10 Mbps full duplex 10PASS-TS: Issues with Clause 62 and related copper clauses

Behrooz Rezvani, Ikanos Communications
Jungwon Lee, Stanford University
Dimitris Toumpakaris, Stanford University

**Issues with Short reach objective for 802.3ah
PHY for single pair non-loaded voice grade copper
distance $\geq 750\text{m}$ and speed $\geq 10\text{Mbps}$ full-duplex**

2.1-b MCM results

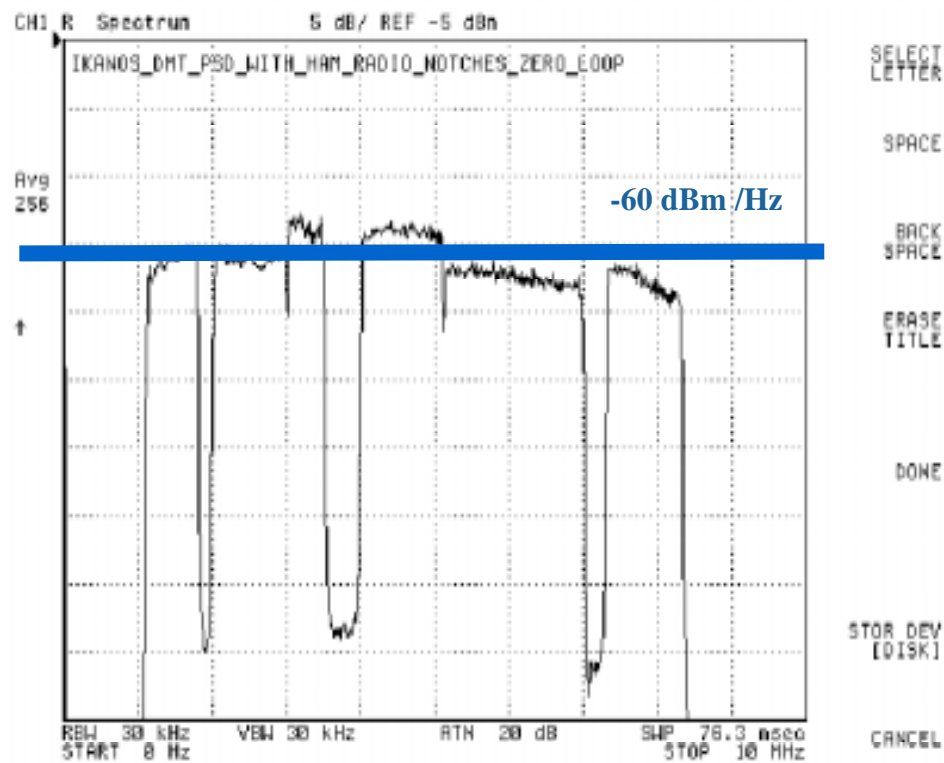
» Reducing tone energy in certain bands to get notches

» Example upstream payload rate simulation

| | | No BT | 1 BT | |
| Notch | | 14.87 | 9.85 | |
| No notch | | 15.22 | 10.08 | |

**998-4-band Symmetric Rate with 48 self-FEXT; 24 at each of 375 and 750 meters
(Standard M1 and M2 masks, FTTcab deployment, noise A environment UPBO)**

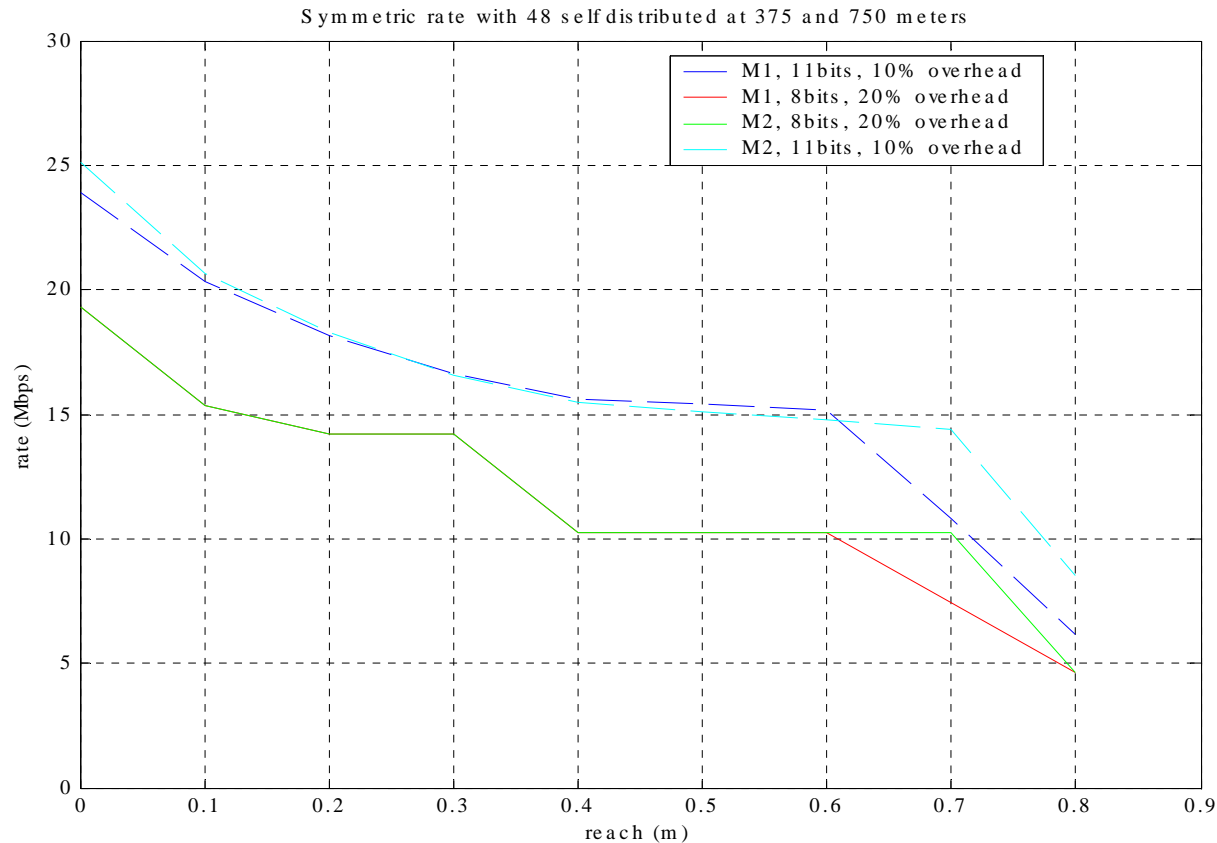
2.2 Simple UPBO and the need for Trellis coding

- » Given that 10 Mbps Full Duplex over 750 meter is not realistic for all conditions then change the objective to 500 meters.
- » Also Change
 - The band plan as suggested to 3 band with 14.5 dBm transmit power, 5.2 dB coding gain which can be done in 4.4 Mhz, spectrally friendly with xDSLs and less effected by short bridge-taps in the CPE side

998-4-band Symmetric Rate with 48 self-FEXT; 12 at each of 0, 250, 500, and 750 meters (Standard M1 mask, FTTcab deployment, UPBO vs. no UPBO)

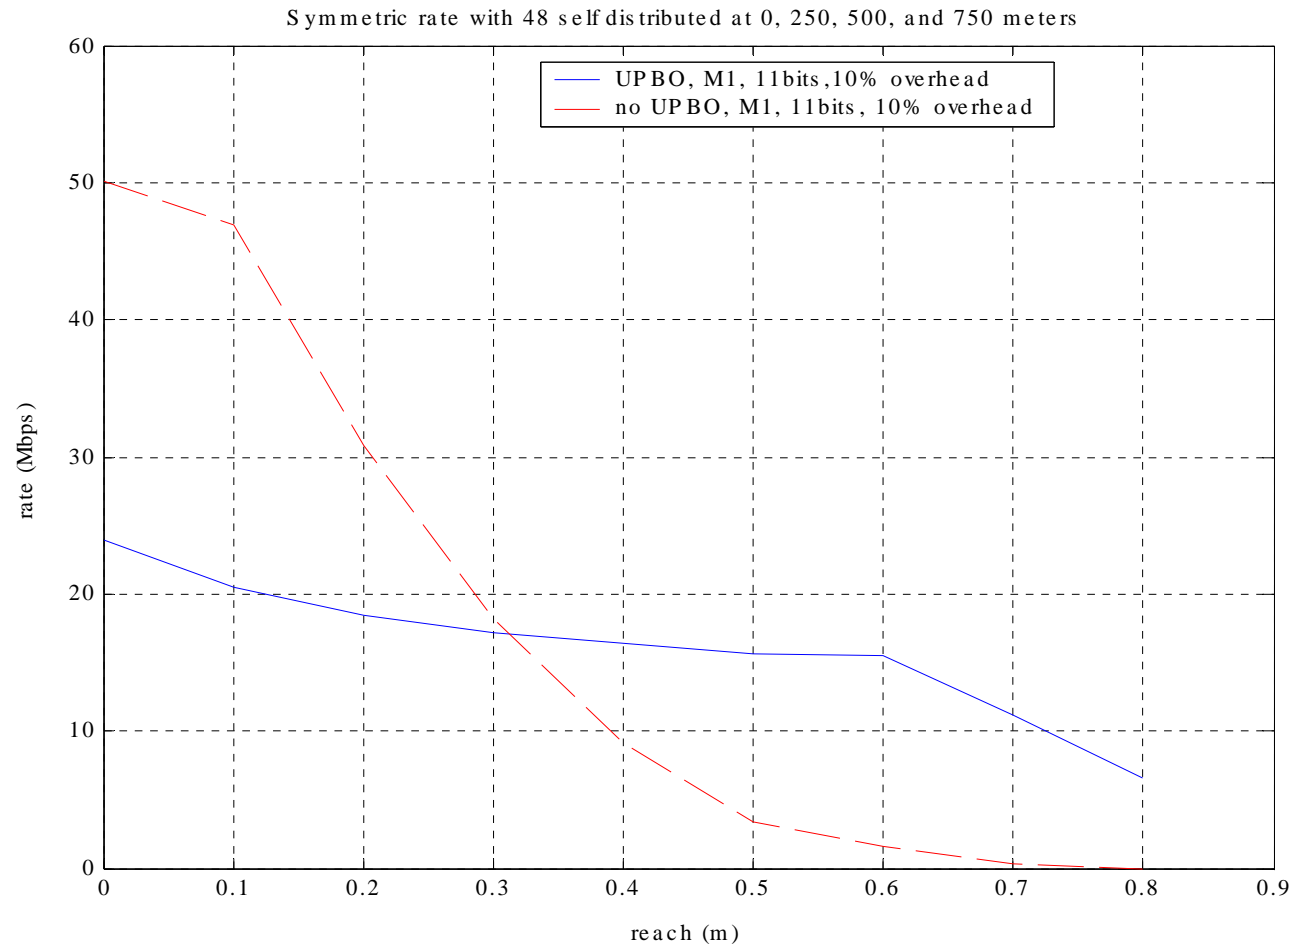
2.2 Simple UPBO
